ORIGINATION FORM

Proposed Revisions to a Standard Plans Index
(Please provide all information — Incomplete forms will be returned)

Index Number: 536-001
Sheet Number (s): 6, 7, 9, and 17
Index Title: Guardrail

GUARDRAIL SECTIONS

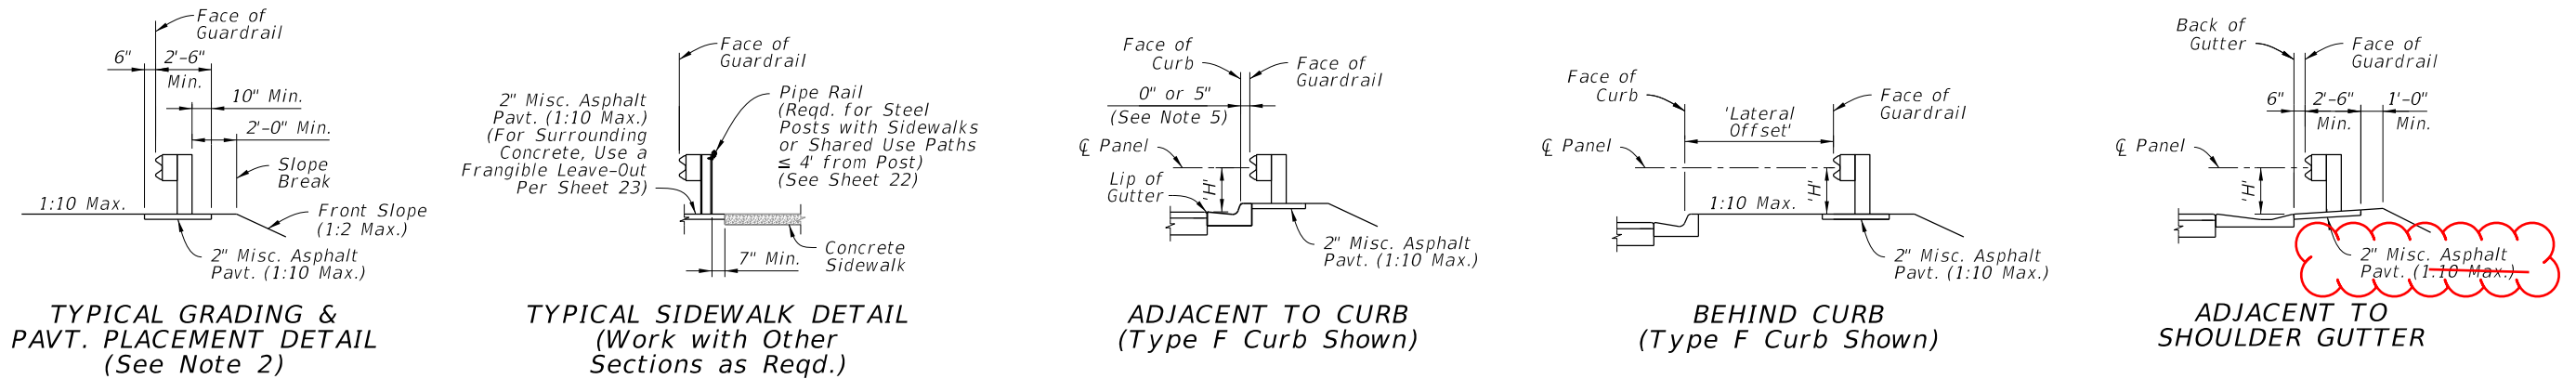
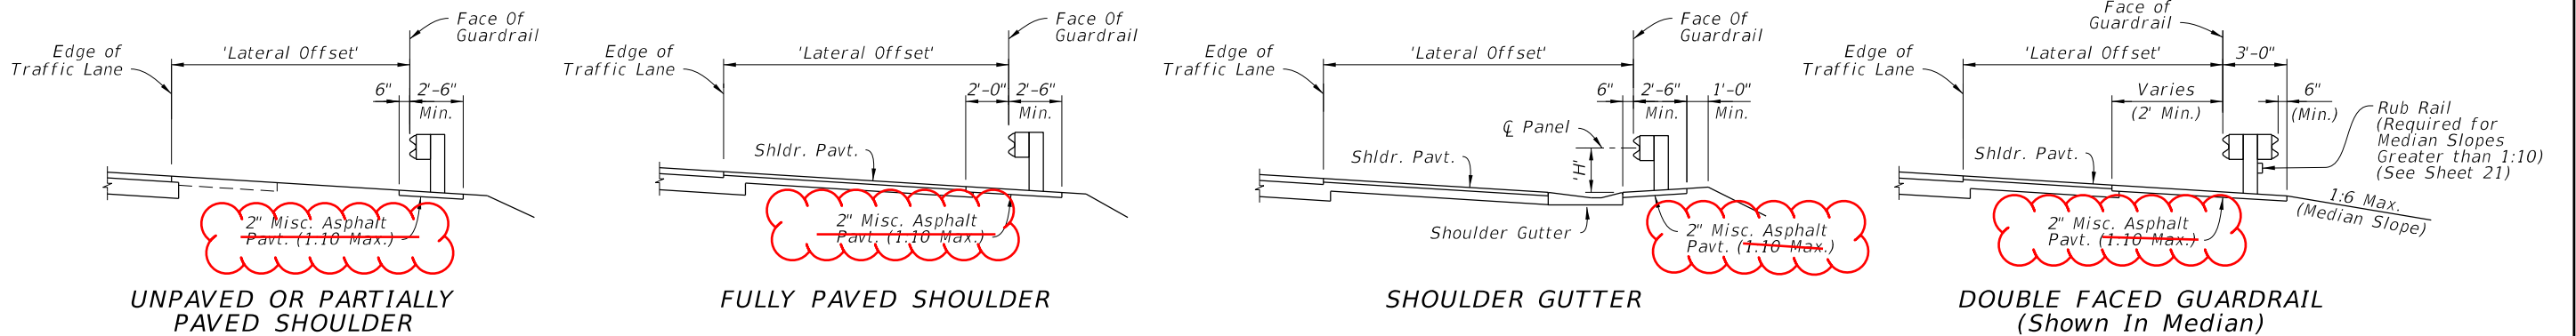
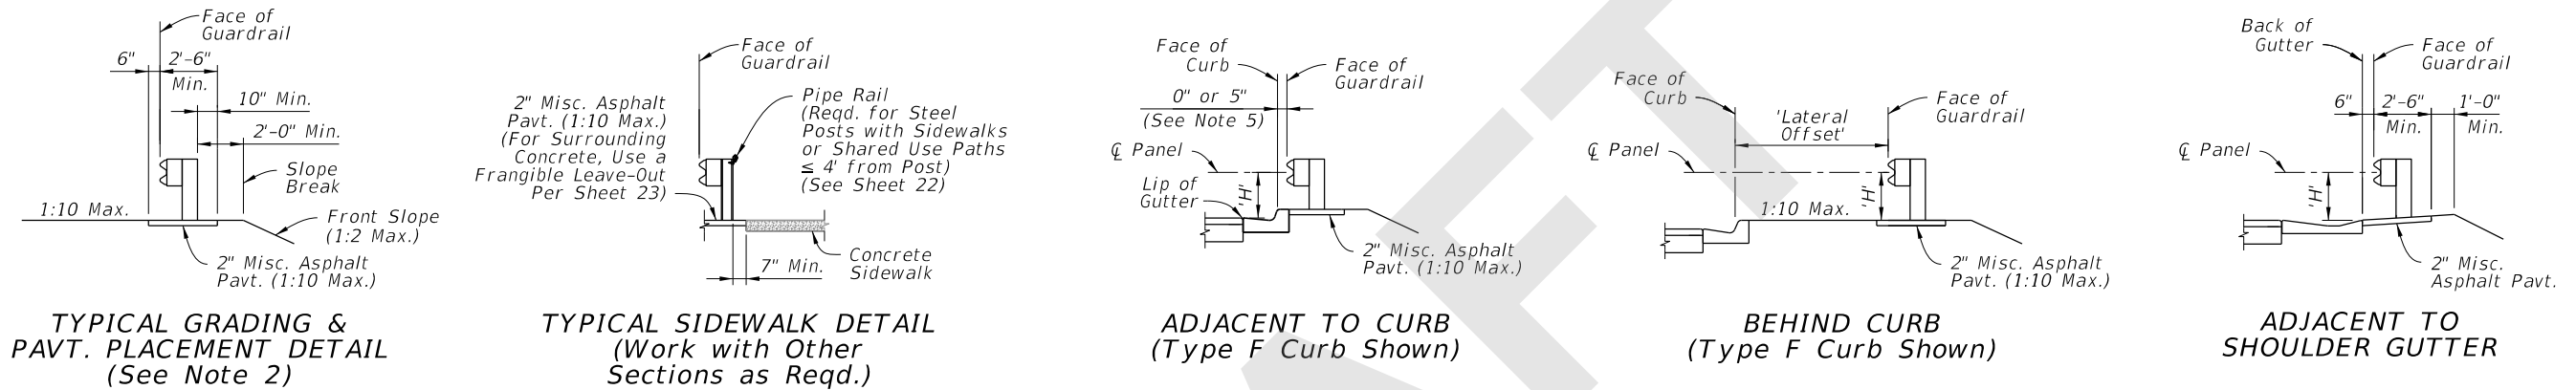
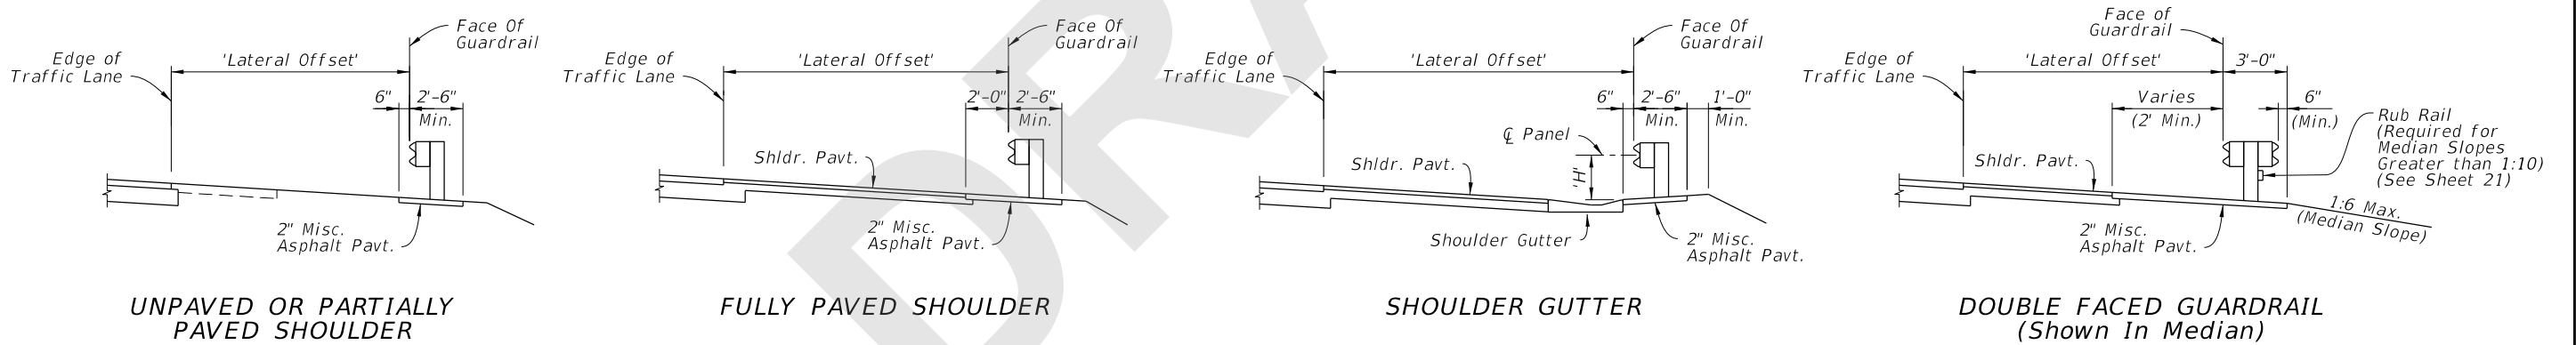
Sheet 6: Removed some 1:10 max. slope labels to clarify that this doesn't alter FDM and drainage slope requirements. Added additional text to note 1 to further clarify.

Added language to explain that additional design criteria governs flatter cross slope

1. GUARDRAIL SECTIONS: Construct Sections as indicated in the plans. The details shown herein depict W-Beam Guardrail, but are applicable to the other defined Guardrail Types placed at the corresponding height, 'H'. Use components per Sheets 4 & 5. Steel and timber post types are interchangeable unless otherwise defined. The 1:10 Max. cross slope shown is the maximum slope permitted for proper guardrail function, but project-specific cross slope requirements are governed by additional design criteria, per the plans.

END TREATMENT -
APPROACH TERMINAL
GEOMETRY - PARALLEL

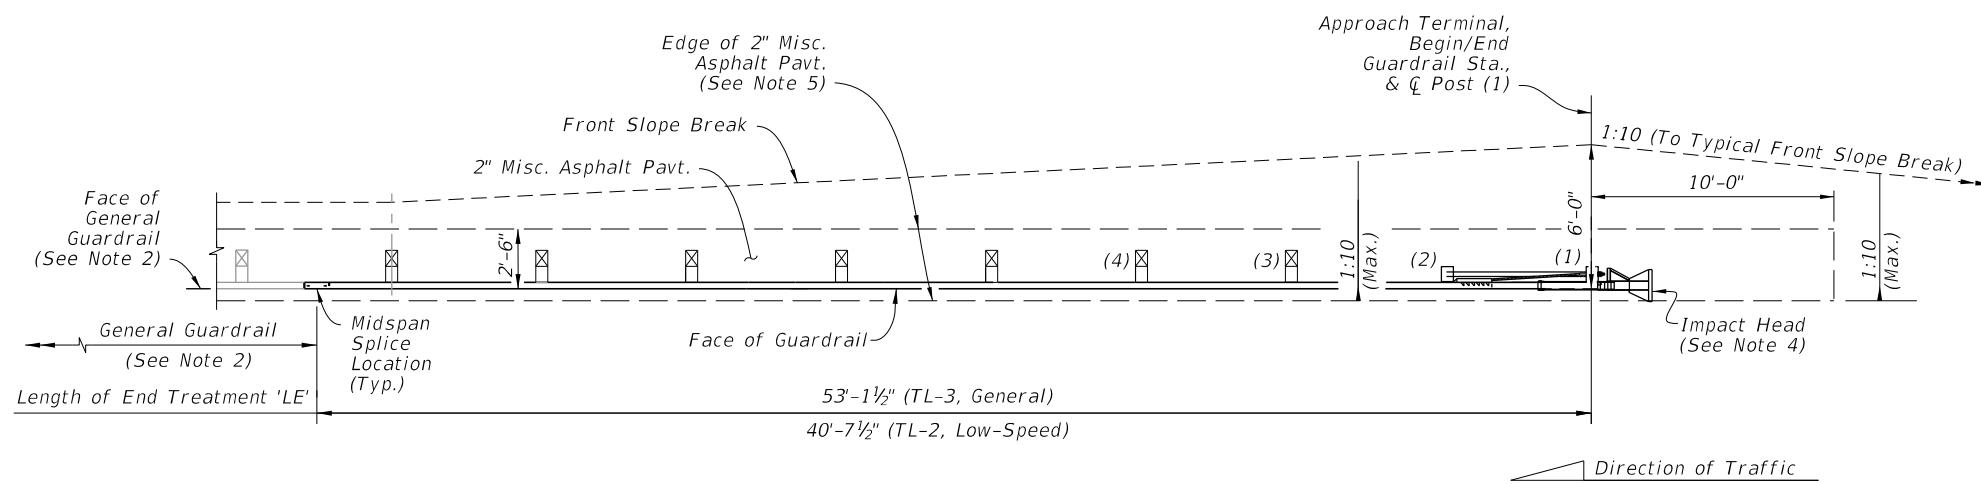
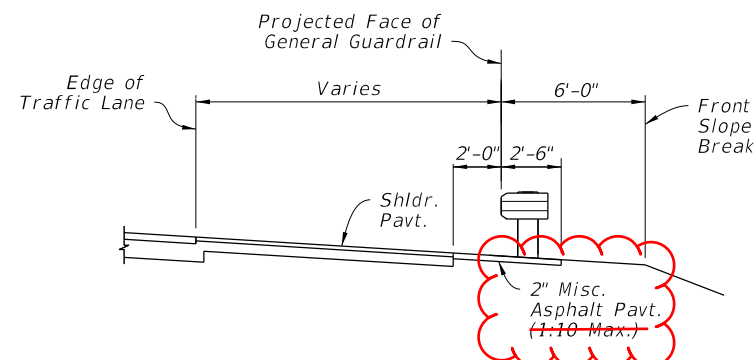
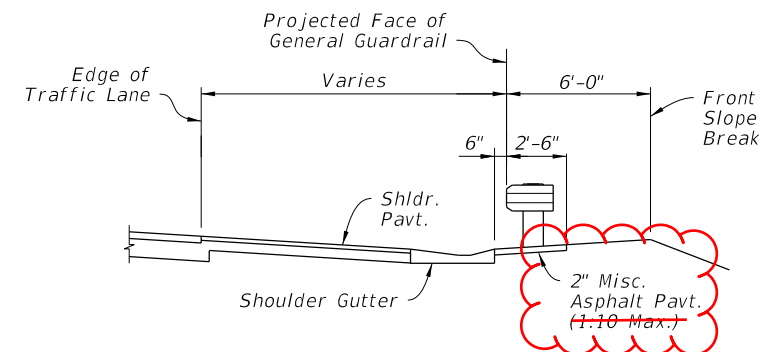
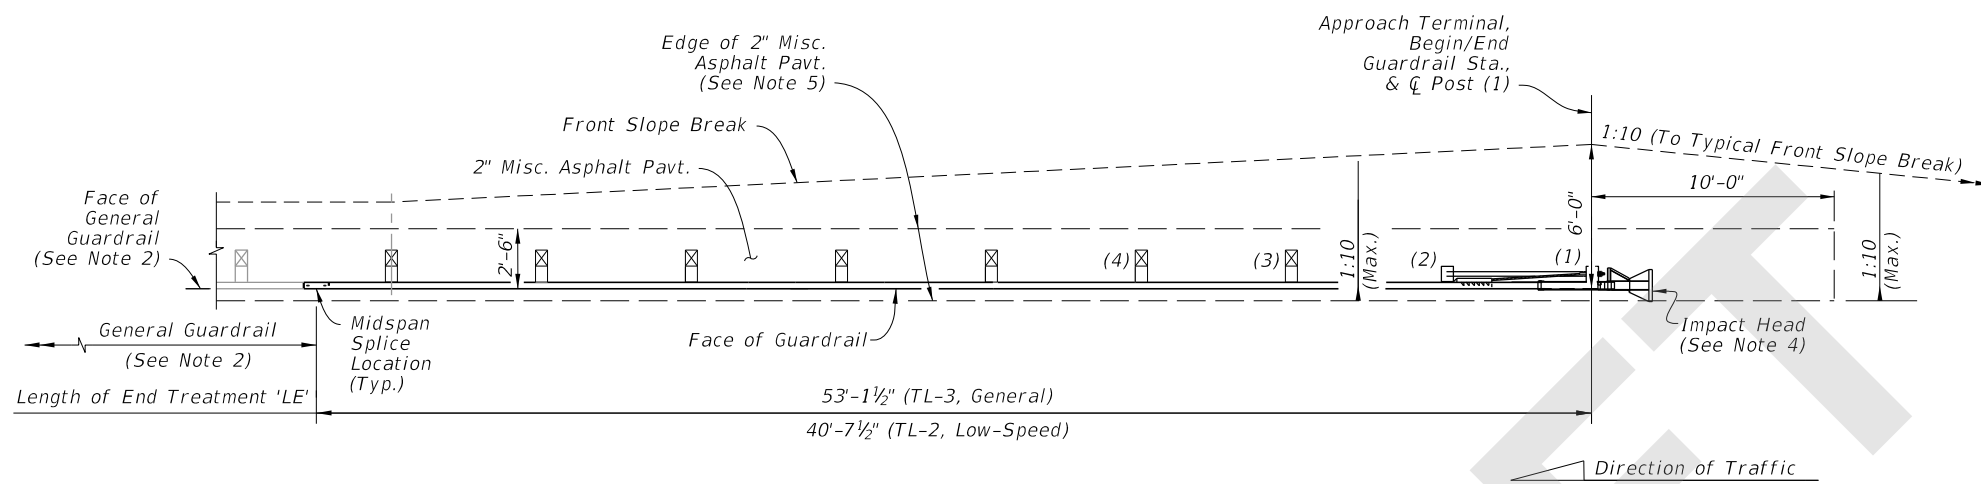
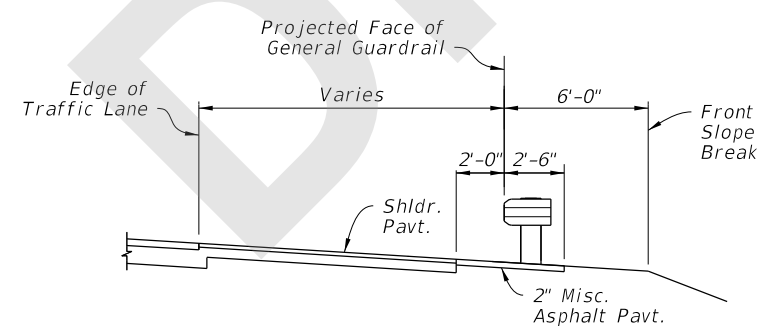
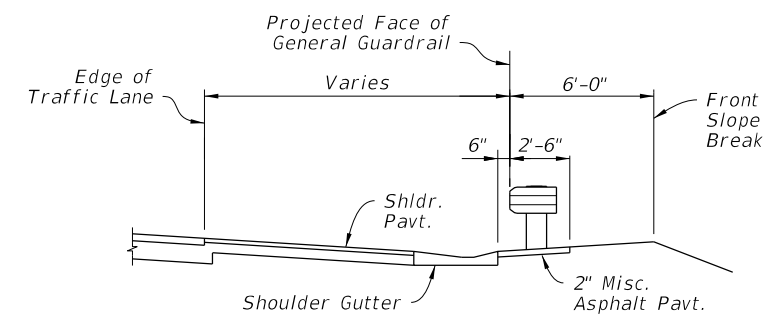
Sheet 7: Removed some 1:10 max. slope labels (similar to Sheet 6)
